APEX MAIN EMS STATION

6950 APEX BARBECUE ROAD, APEX, NORTH CAROLINA 27502 | WAKE COUNTY REQUEST FOR BIDS NUMBER: RFB-23-080

ADDENDUM NO. 2

DATE: OCTOBER 19, 2023

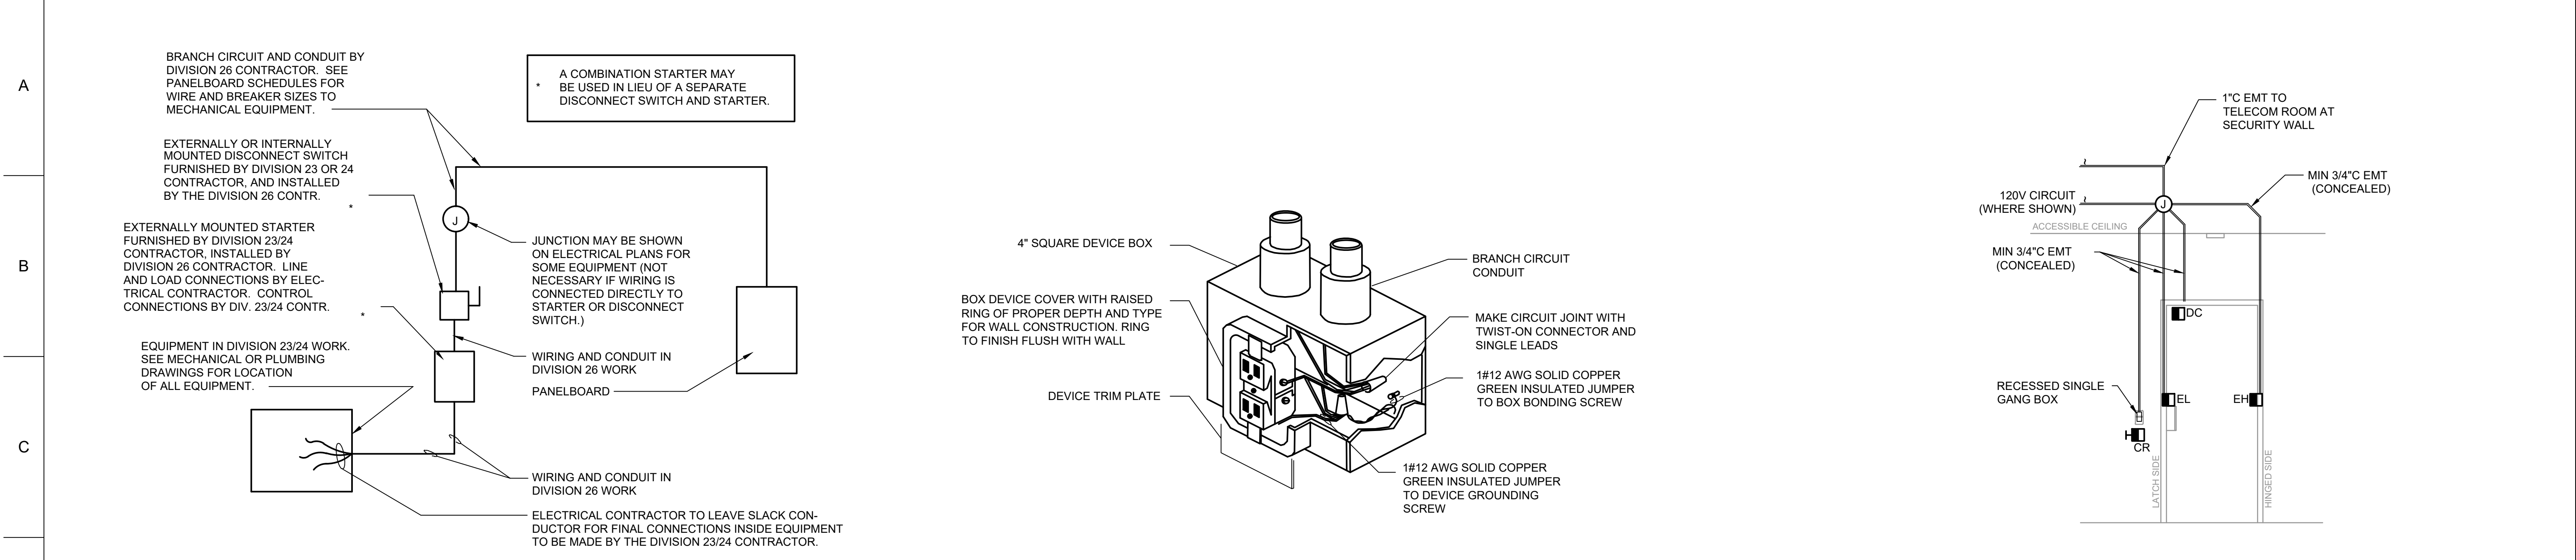
1. **REPLACE** Sheet E102 – Electrical Power New Work Plan with the attached, updated E102 – Electrical Power New Work Plan (Revision 2, Dated 10/19/23). GFCI and Data Outlet revisions. Additional General and Keynotes added. 1-Hour rated wall graphic representation added to Supervisor 103 rated walls as previously noted in Addendum No. 1.

6 TRUCK PLUG CONNECTION DETAIL
SCALE: NTS

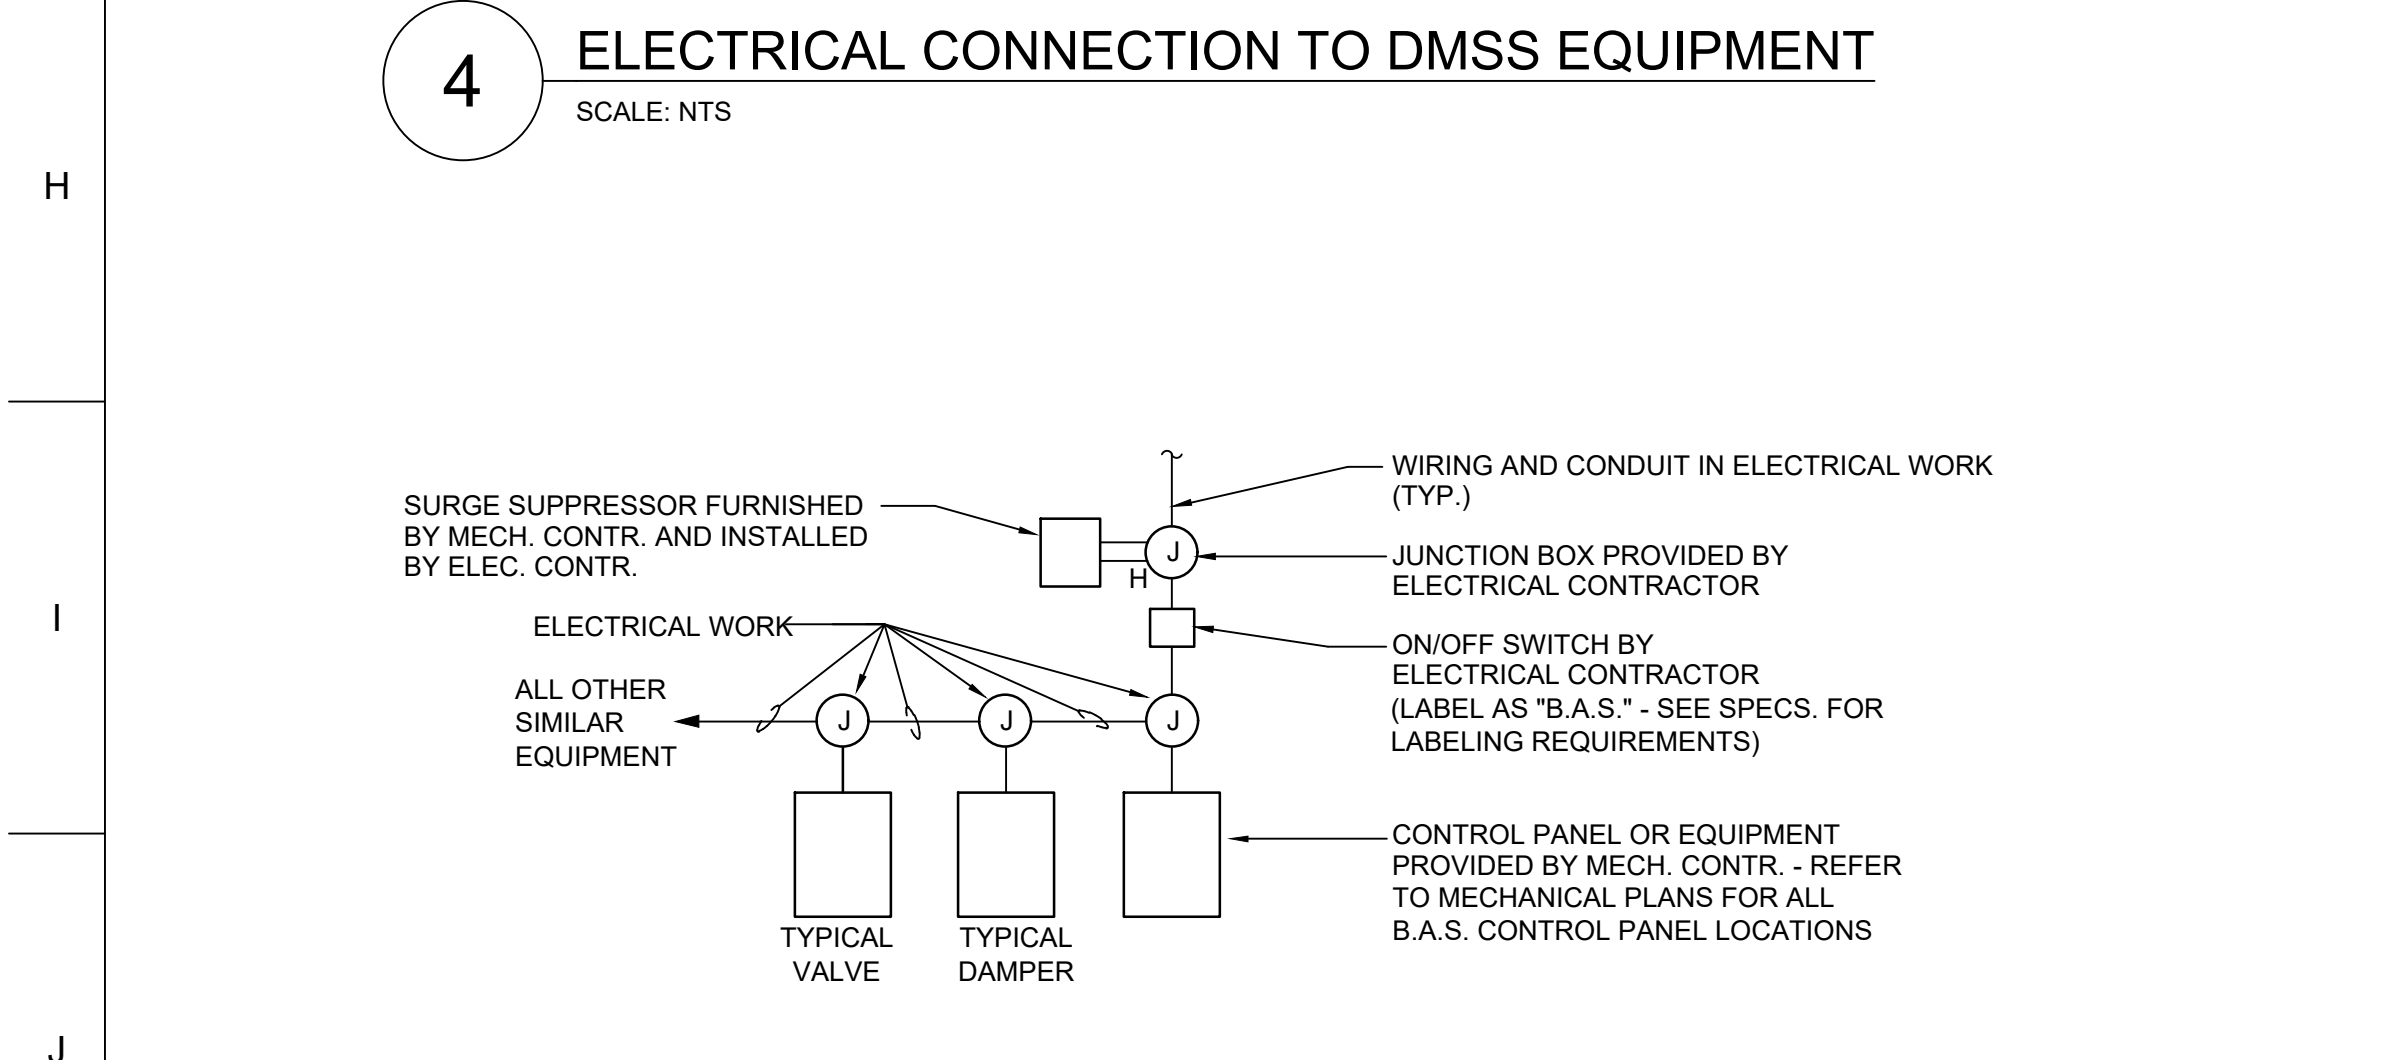
1. **REPLACE** Sheet E402 – Electrical Details with the attached, updated E402 – Electrical Details (Revision 2, Dated 10/19/23). Truck Plug Connection Detail updated.

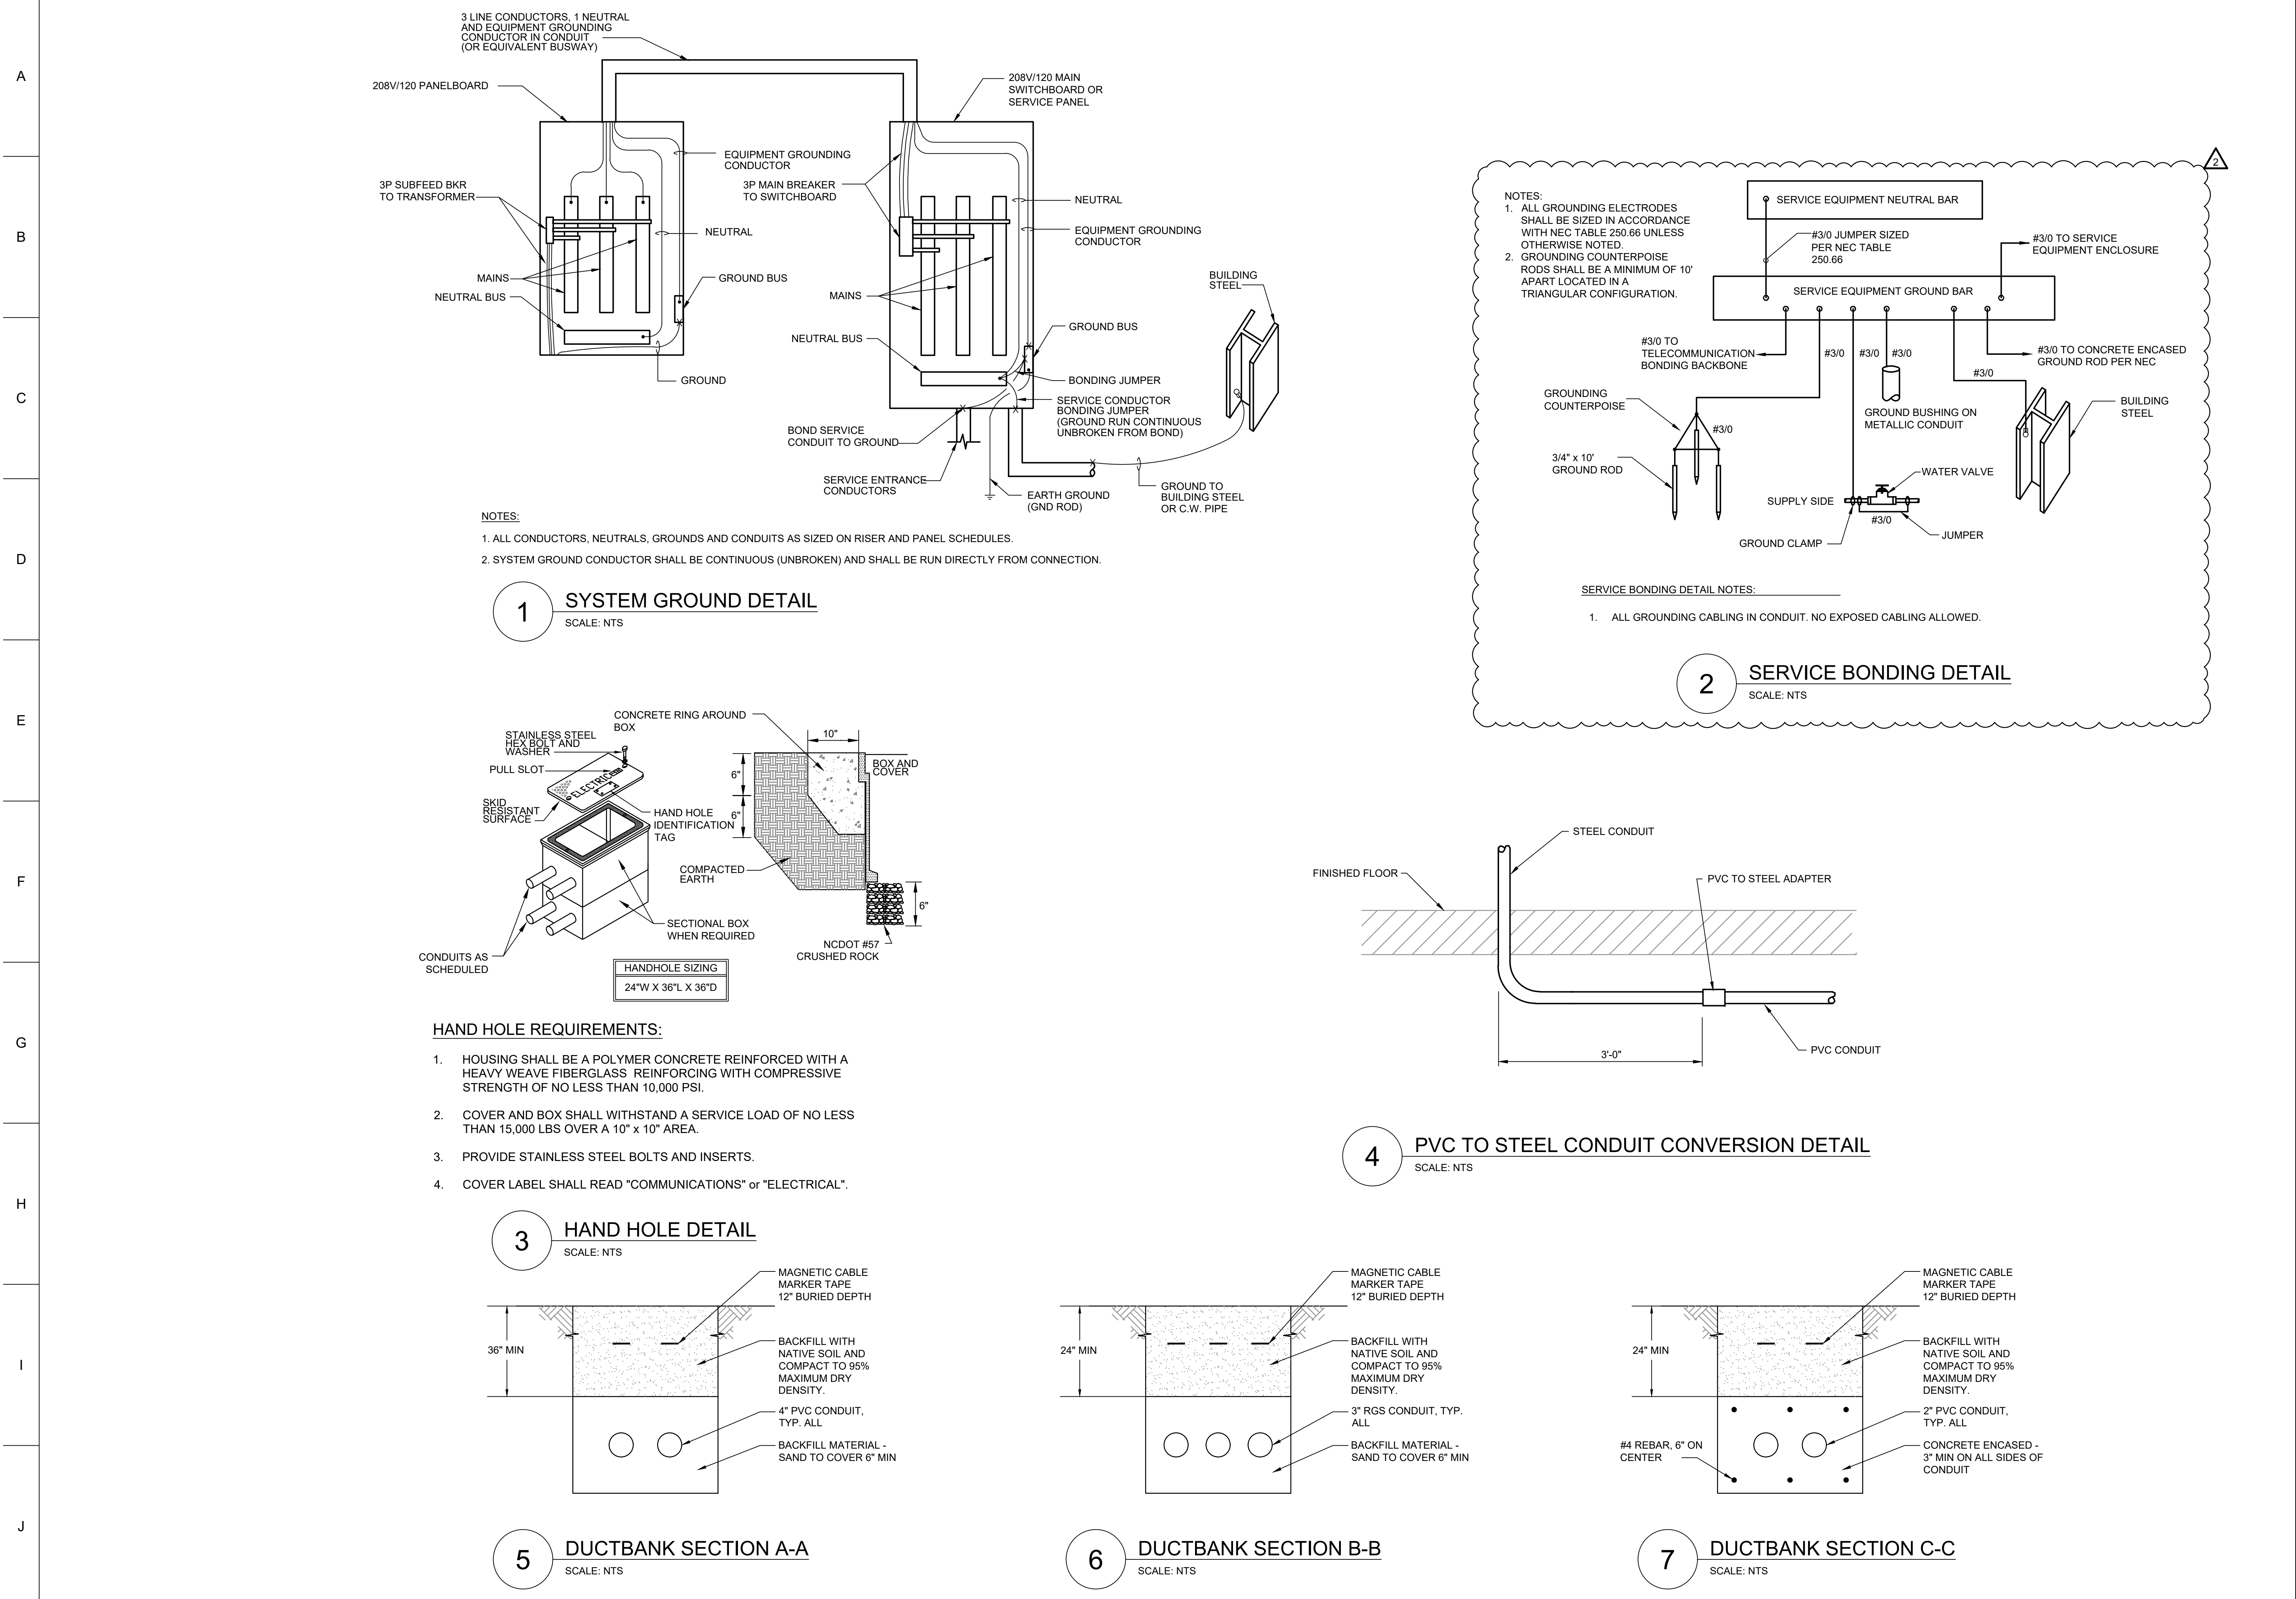
1. **REPLACE** Sheet E404 – Electrical Details with the attached, updated E404 – Electrical Details (Revision 2, Dated 10/19/23). Service Bonding Detail updated.

3 PARTIAL SCADA SYSTEM SCHEMATIC
SCALE: NTS
NOTE: SEPARATE PERMITS REQUIRED FOR GENERATOR AND SOLAR PANELS.

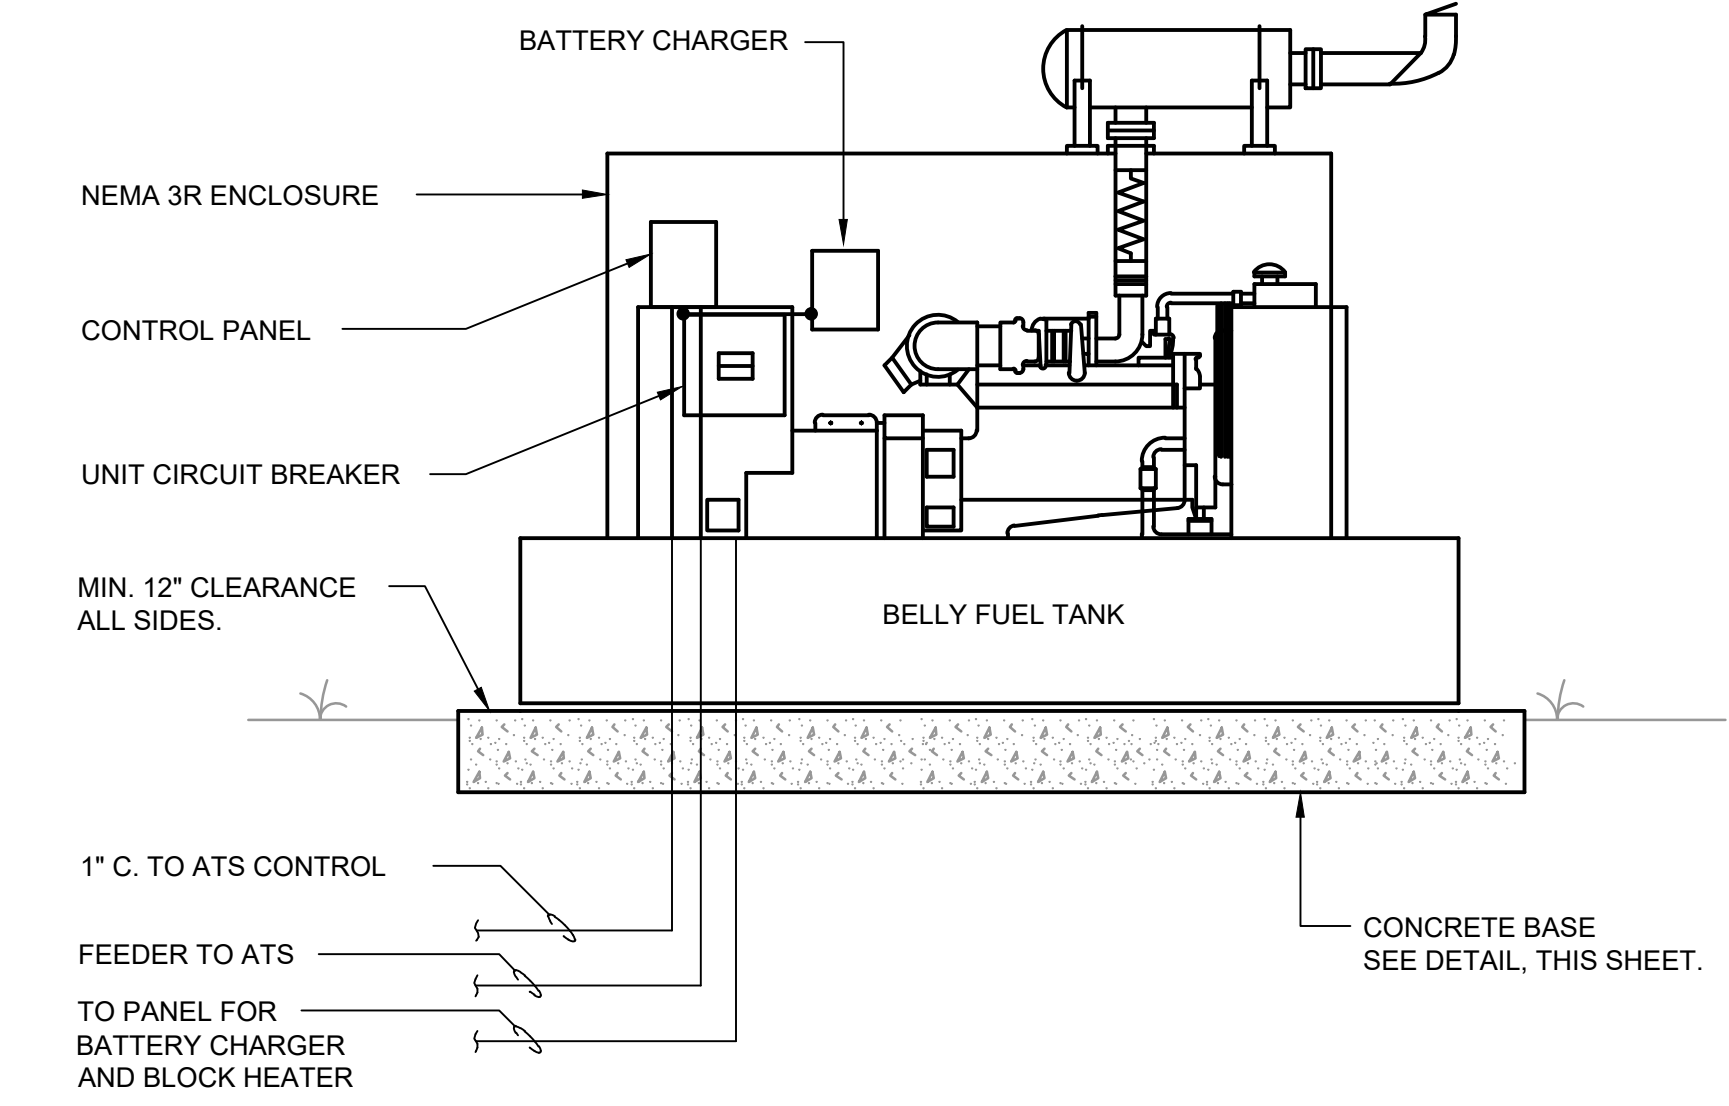
1. **REPLACE** Sheet E406 – Electrical Details with the attached, updated E406 – Electrical Details (Revision 2, Dated 10/19/23). Partial SCADA System Schematic updated. Note added to Generator Detail.

2 TELECOM EQUIPMENT RACK ELEVATION
SCALE: NTS

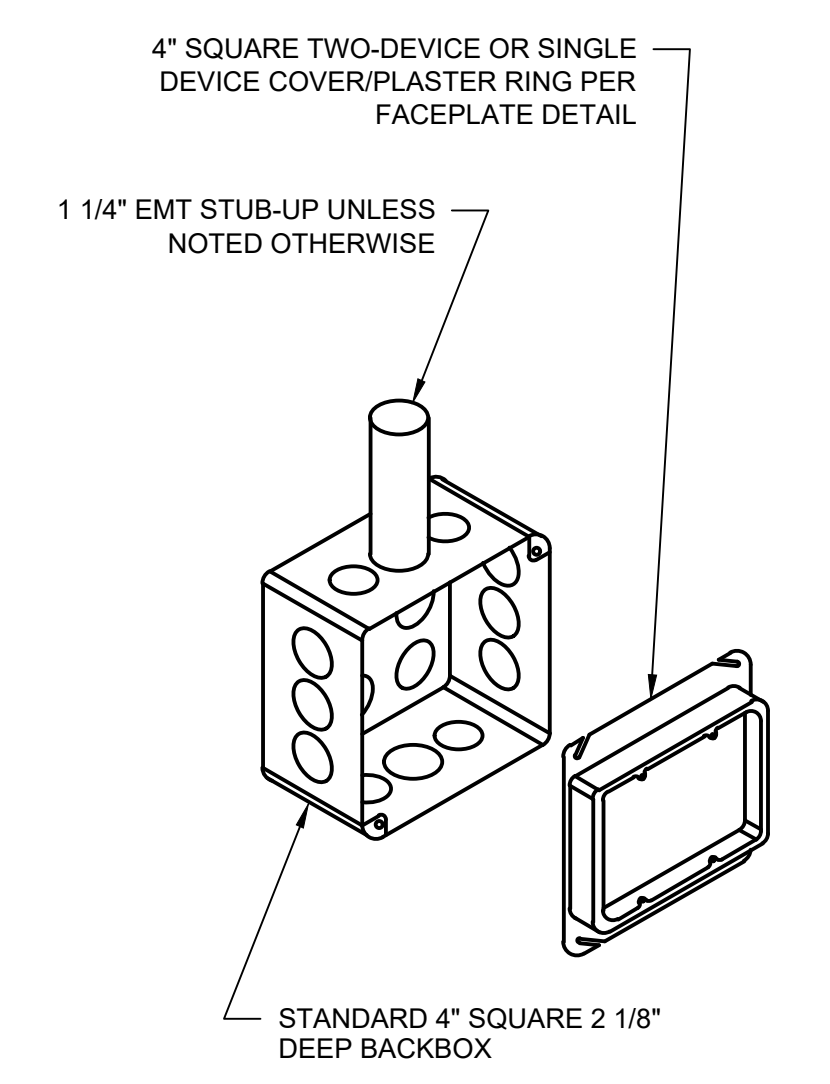
1. **REPLACE** Sheet E408 – Electrical Details with the attached, updated E408 – Electrical Details (Revision 2, Dated 10/19/23). Telecom Equipment Rack Elevation and Typical Telecom Faceplate Detail updated.
